Steve Long's estimates of cavity dimensions and the material from licensee that was Long's basis for his estimates

From: <mkleisure@firstenergycorp.com>
 To: <jbh1@nrc.gov>
 Date: 8/23/02 2:01PM
 Subject: RE: NRC Request re: Cavity Mold

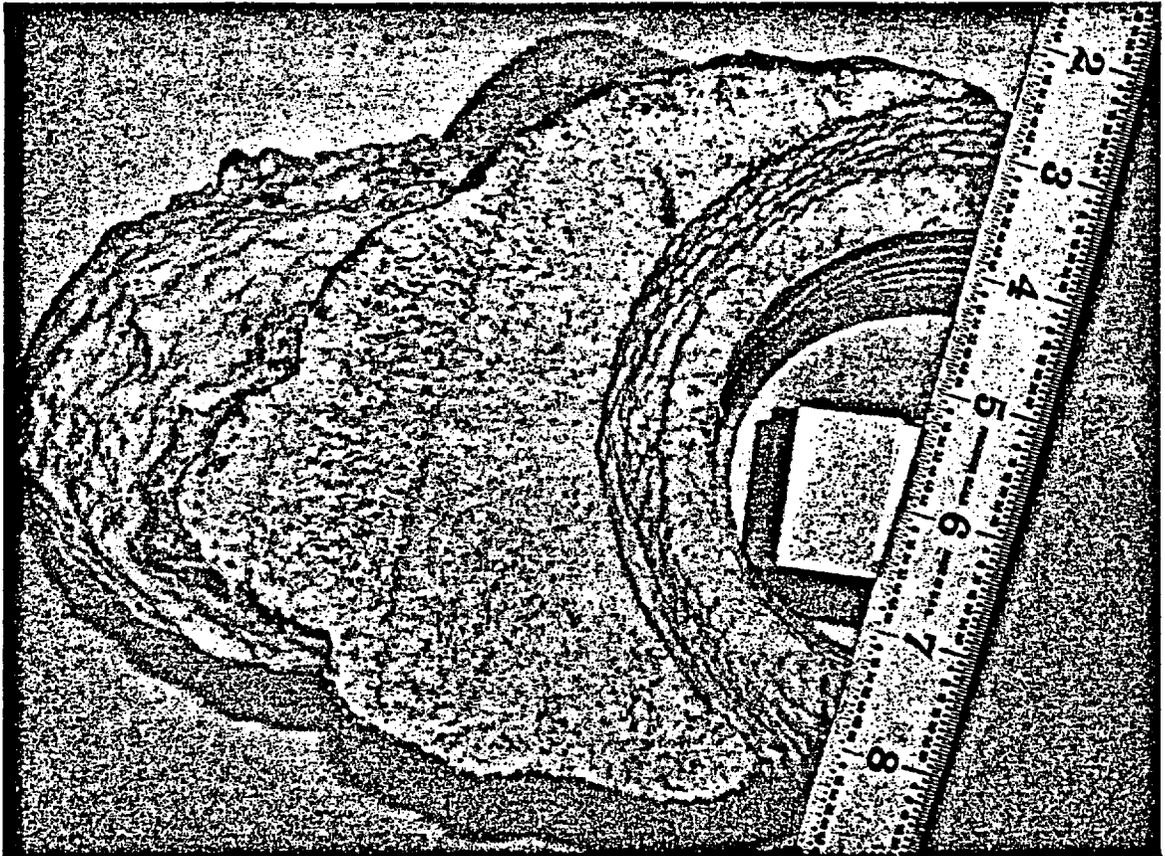
Based on the photos (particular slide #12) in the 6/17/02 presentation at BWXT and photos for the exposed cladding area measurement (word doc in my 8/7/02 email to you), the shortest distance from the nozzle #3 O.D. to the extremity of the cavity (i.e. the farthest point of the nose) is estimated to be 5.9+/- 0.2 inch.

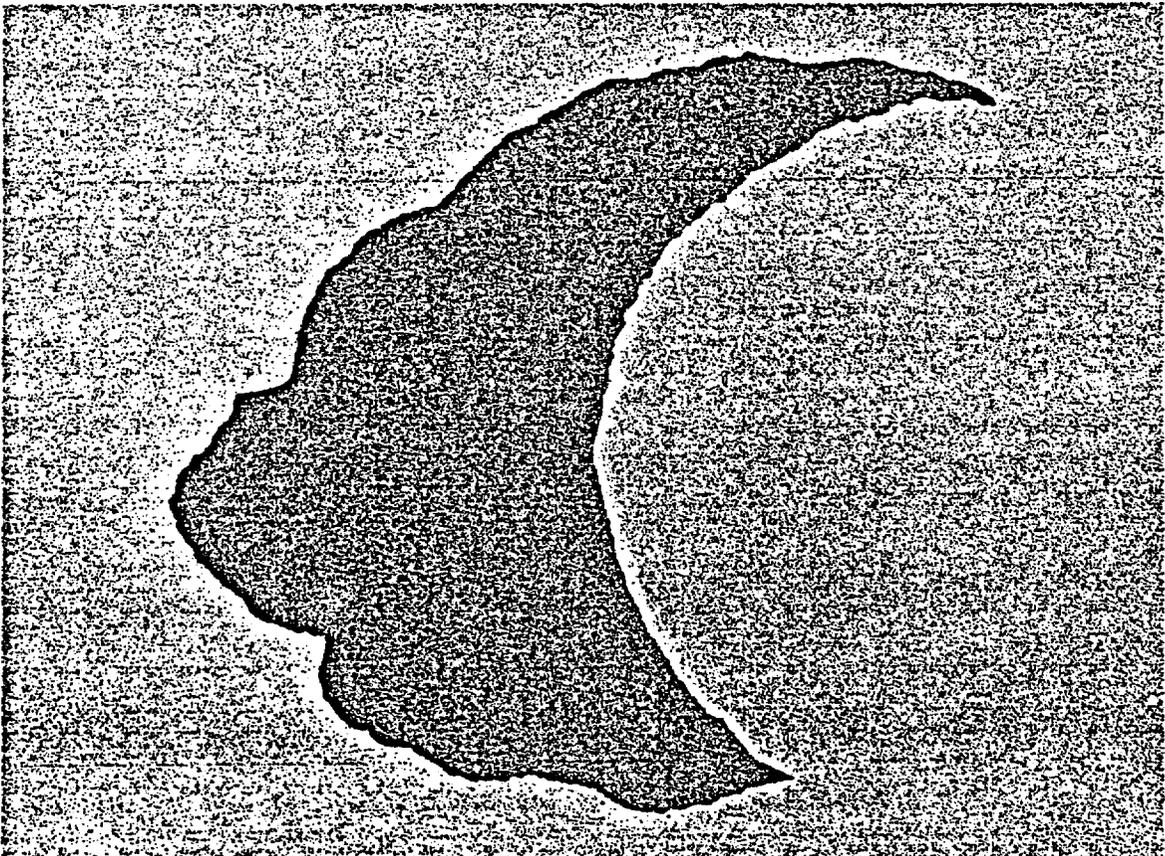
Magnification: $6''/3.82'' = 1.57X$
Area of photo: $(6'')(1.57) \times (4.5'')(1.57X) = 66.55 \text{ in}^2$

Area fraction of exposed cladding: 25.95% (by image analysis software)
Area of exposed cladding: $(66.55 \text{ in}^2)(.2595) = 17.27 \text{ in}^2$
